SHALLOWFORD PLACE

SITE PLAN

PETITION NO: Z-111

ZONING COMMENTS:

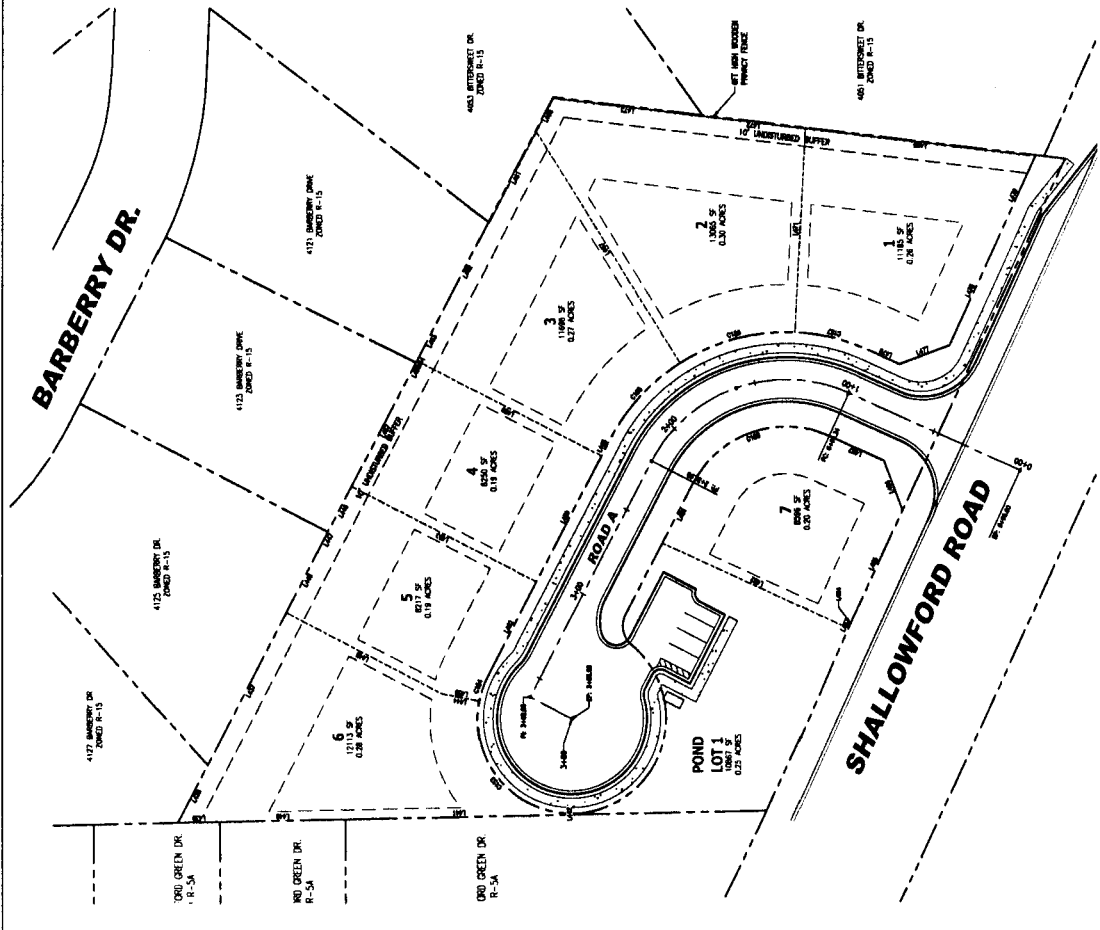
The applicant is requesting a rezoning to the RA-5 single-family residential district in order to develop a seven-lot single-family subdivision. That district’s minimum lot size of 7,000 sq. ft. will be met with the lots ranging from 8,217 sq. ft. to 13,065 sq. ft. The proposed homes will be a minimum of 2,500 square feet and be constructed with brick, stone, stacked stone, cedar shake, board and batten, or combinations thereof. The Code-required 10 foot landscape buffer is provided adjacent to more restrictively zoned (R-15) properties, which is shown.

- Provide comprehensive hydrology/stormwater controls to include development of out parcels.
- Submit all proposed site improvements to Plan Review.
- Any **spring activity** uncovered must be addressed by a qualified geotechnical engineer (PE).
- Structural fill _____ must be placed under the direction of a qualified registered Georgia geotechnical engineer (PE).
- Existing facility.
- Project must comply with the Water Quality requirements of the CWA-NPDES-NPS Permit and County Water Quality Ordinance.
- Water Quality/Quantity contributions of the existing lake/pond on site must be continued as baseline conditions into proposed project.
- Calculate and provide % impervious of project site.
- Revisit design; reduce pavement area to reduce runoff and pollution.

- No Stormwater controls shown _____
- Copy of survey is not current – Additional comments may be forthcoming when current site conditions are exposed.
- No site improvements showing on exhibit.

1. This site is located just north of Shallowford Road and is bounded on the north and east by Hedgerow Subdivision and on the west by Shallowford Green Subdivision. Slopes on the site are relatively mild ranging from 2 to 10%. The majority of the site (2/3) drains to the Shallowford Road R/W. The remaining third drains to the east into the Hedgerow Subdivision Recreation Area.
2. Any bypass runoff from the rear of lots 1 through 7 must be directed to the Shallowford Road right-of-way and not to the Hedgerow Rec Area.

Recommend curb and gutter along both sides and sidewalk along one side of proposed development roadway.

Recommend guest parking be located outside of the right-of-way.

1. Site plan dated September 1, 2016 with District Commissioner approving minor modifications;
2. Fire Department comments and recommendations;
3. Water and Sewer Division comments and recommendations;
4. Stormwater Management Division comments and recommendations;
5. Department of Transportation comments and recommendations;
6. Owner/developer to enter into a Development Agreement pursuant to O.C.G.A. §36-71-13 for dedication of system improvements to mitigate traffic concerns; and
7. House architecture to be approved by the District Commissioner.
